CONDITIONS OF APPROVAL:

Engineering - PUD Plan Checklist

Engineering - Site Plan Checklist

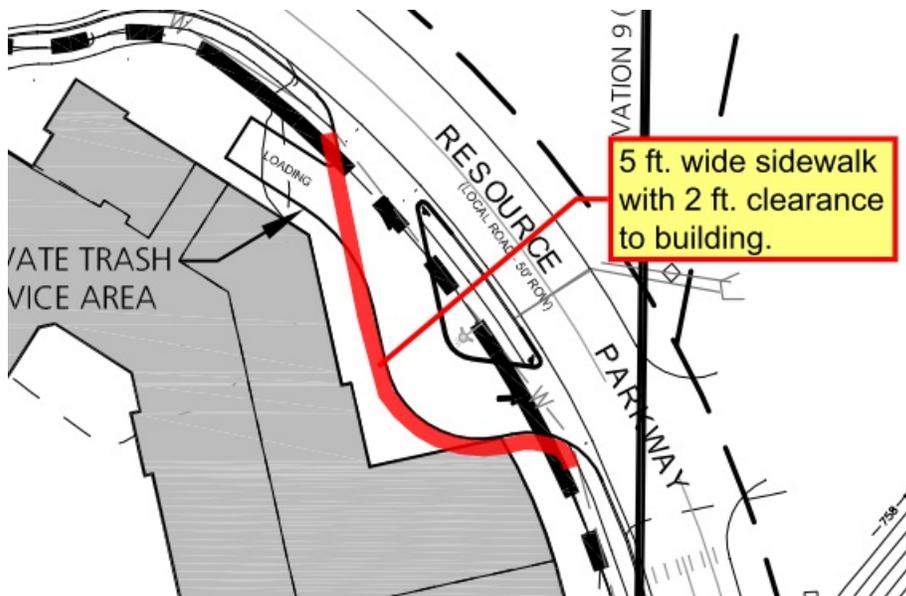
joseph.marlo@franklintn.gov The loading area may be allowed if, in addition to the modifications/adjustments made, the applicant shifts the 5-foot wide sidewalk around to the southwest edge of the area as shown in the sketch below. A minimum 2-foot clearance shall be maintained between the back edge of the sidewalk and the nearest building.
